THERMINOL® CONVERSION BULLETIN

SP/TC-1

Monsanto

FIGURE 4
SUGGESTED INERT GAS ARRANGEMENT FOR EXPANSION TANK

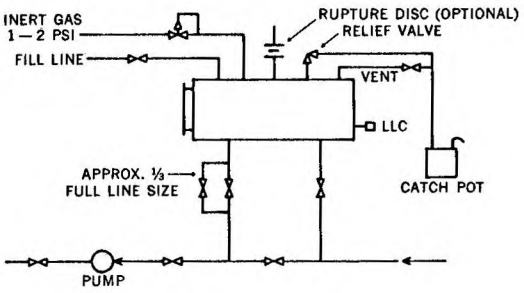
Oxidation of fluid can develop by air contact in an open, vented expansion tank. Therefore, we recommended that the expansion tank be blanketed with an inert gas (such as nitrogen) as shown in Figure 4. If this is not possible, air contact can be minimized by a cold seal arrangement as shown in Figure 5. An inert gas pressure of one to two psi is adequate, as Therminol 55 and 66 do not require pressurization to maintain liquid phase.

FIGURE 5
SUGGESTED COLD SEAL TRAP ARRANGEMENT
FOR EXPANSION TANK

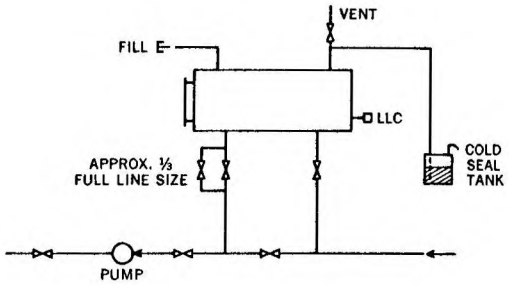
You can design the cold seal arrangement quite simply by piping the expansion tank vent to a second tank where the vent line projects subsurface and can be flooded with additional Therminol 55 or 66 to minimize air contact in the expansion tank vapor space.
